**LOWER PROVIDENCE TOWNSHIP
RESOLUTION NO. 2019-37
(LD-19-03)**

**A RESOLUTION OF THE LOWER PROVIDENCE TOWNSHIP BOARD
OF SUPERVISORS, MONTGOMERY COUNTY, PENNSYLVANIA,
APPROVING THE PRELIMINARY/FINAL MINOR LAND
DEVELOPMENT PLAN FOR 9 S. PARK AVENUE, PROPERTY OF
ROBERT & ANNE MARIE GAMBONE**

Reference: 9 South Park Avenue – Land Development Application

SUBJECT: **REVIEW COMMENTS - 9 SOUTH PARK AVENUE (AMERICAN TILE)**
TENTATIVE SKETCH PLAN DATED REVISED AUGUST 5, 2019

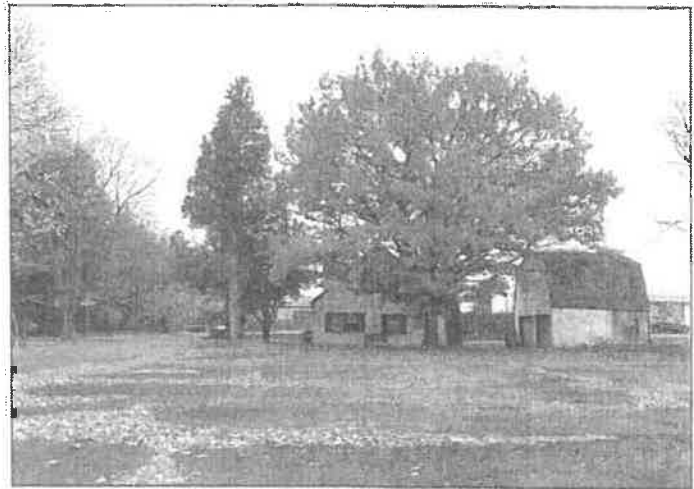
3.C North Property Line Screen Buffer & Scarlet Oak Preservation

The proposed Emerald Green Arborvitae would provide a suitable "primary" buffer along the north property line as well, adjacent to the (apparently) residential use at 2805 2nd Street.

However, as seen in the photographs below, there is a Scarlet Oak on or near the shared north property line. Based on the pavement treatment, it may on the neighboring property. Although this tree has been growing under adverse conditions (a lack of direct water infiltration plus reflected heat from the pavement), it appears to be healthy and we recommend that every effort be made toward its successful preservation, particularly if it is on the neighboring property.

Per our field measurements, the low canopy of this tree extends 30 feet outward into the subject property (toward the left of the above-left photo). The subsurface root system likely extends approximately this distance as well, below the pavement.

1. The enormous physical disturbance necessary to remove pavement, while seemingly a worthwhile end goal to reduce overall impervious coverage and provide new planting, may irreparably harm this tree's root system. Digging holes for new tree planting would also disturb this tree's root system.
2. There is insufficient vertical space under much of this tree's canopy to plant the proposed Emerald Green Arborvitae.

If it is determined that efforts should be focused on preserving this tree, an attractive, perhaps lattice-top five to six foot (5'-6') high wood, composite or high-quality vinyl fence installed into the existing pavement may be a good solution for providing screening that meets the intent of the SLDO residential screening requirement. A fence that is solid for at least its lower four feet (4') would also do a better job of blocking headlight glare than would the Arborvitae.
